AGENDA
President and Board of Trustees
Village of Arlington Heights
Board Room

Arlington Heights Village Hall
33 S. Arlington Heights Road
Arlington Heights, IL 60005
November 7, 2022
7:30 PM

***Project Number**: PC #22-008*
***Project Title**: Ecole 360 Childcare Center*
***Address**: 1515-1519 W. Dundee Rd.*
***PIN**: 03-07-102-014*

01 - Picket fence principal details

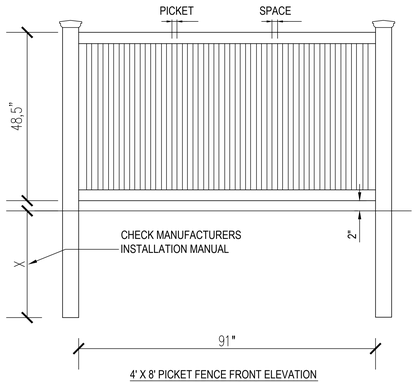
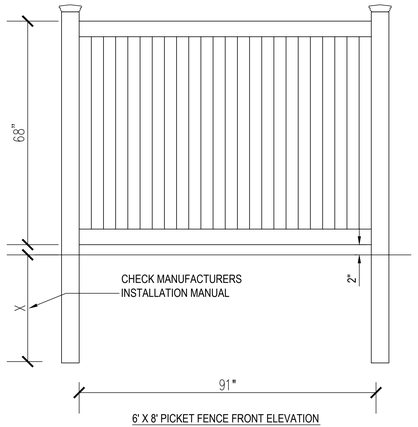
33. The response to comment #18 is noted. All gates shall be white vinyl in a style and height to match the fence.

PROPOSED STRUCTURES, DRAINAGE, & SITE UTILITIES

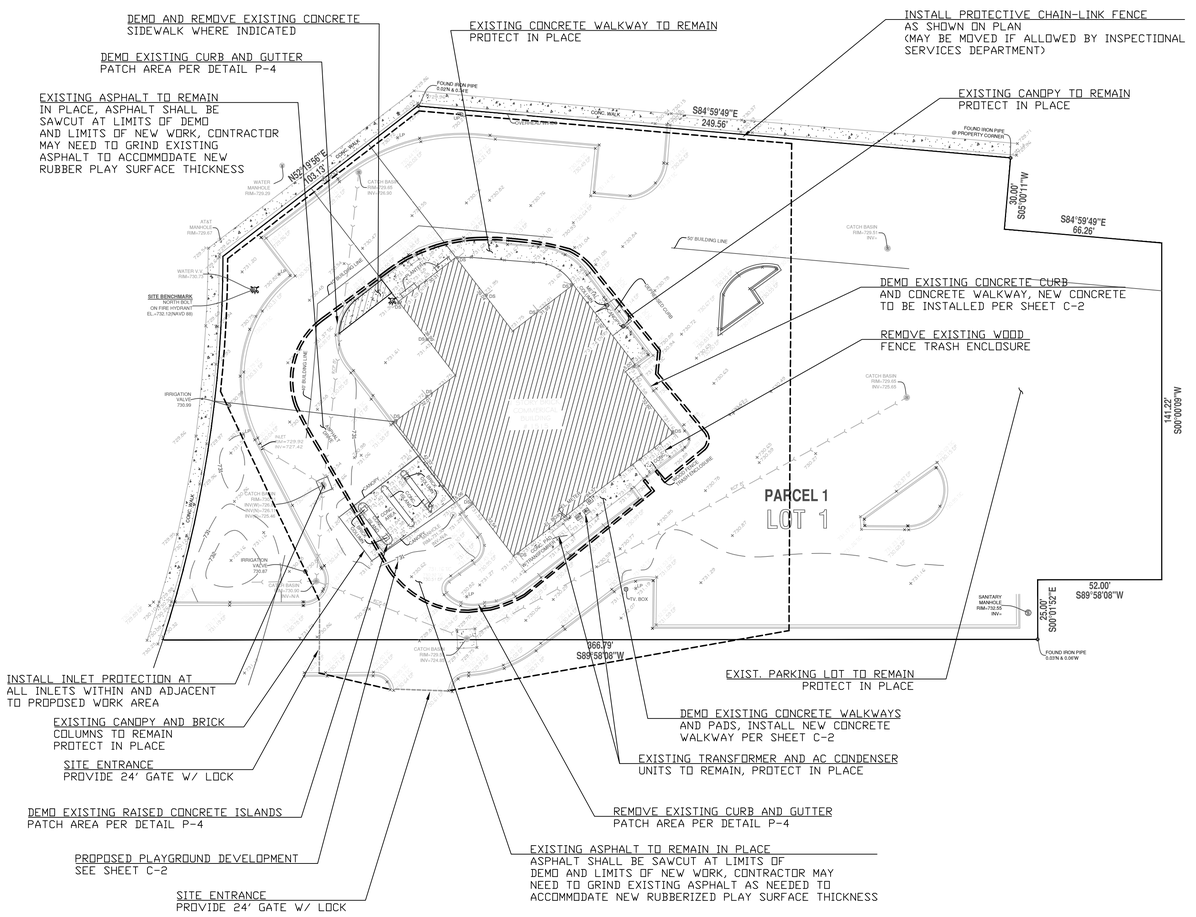
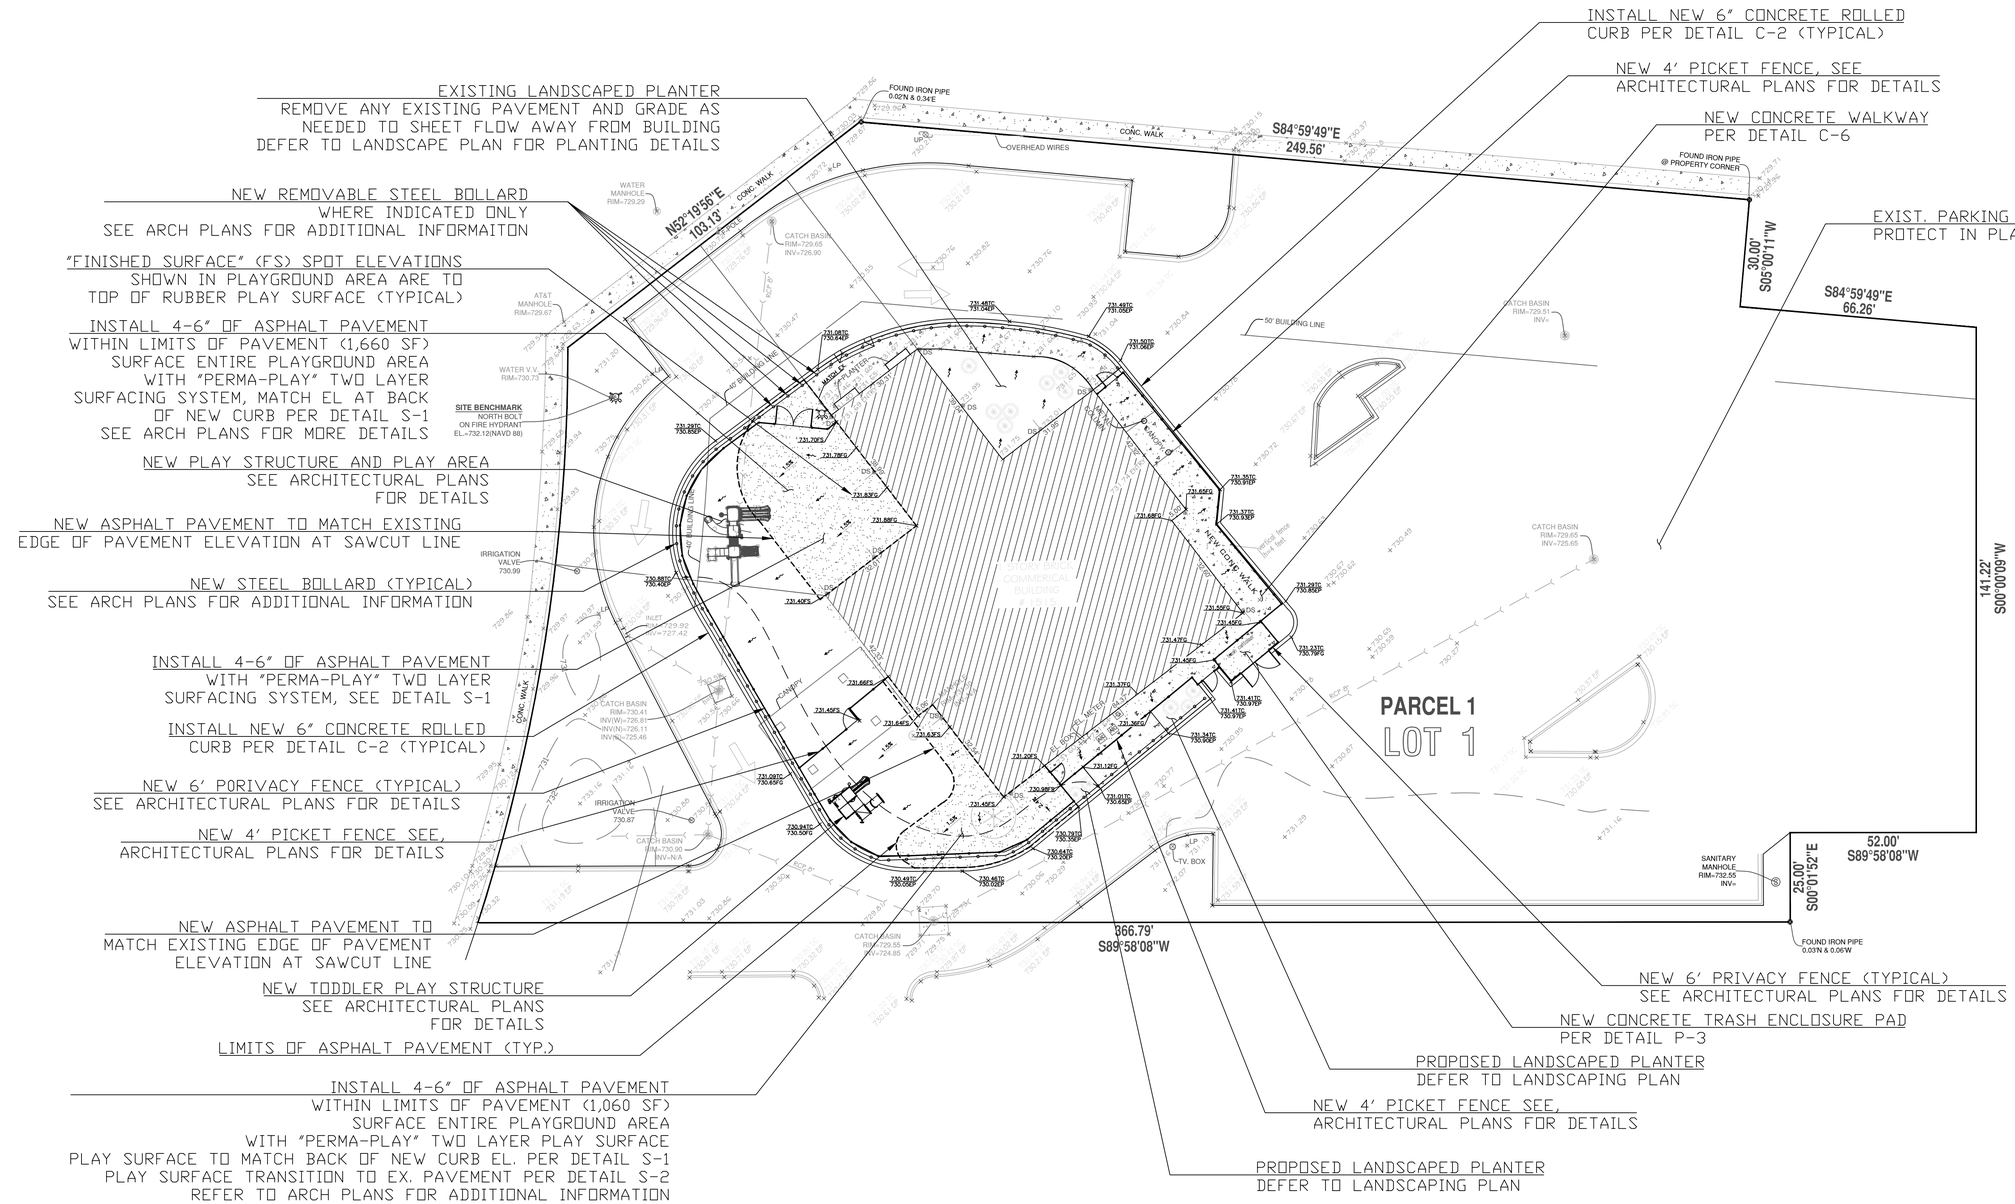
24. The petitioner's response to comment no. 17 is noted. Detail C6 is not shown on the engineering plan. This can be addressed at permit.

Page 1 Query 24. The expression of "Detail C-6" is a typing error. It shall be "Detail P-6". Related revision will be incorporated into design drawings in the construction permit design stage.
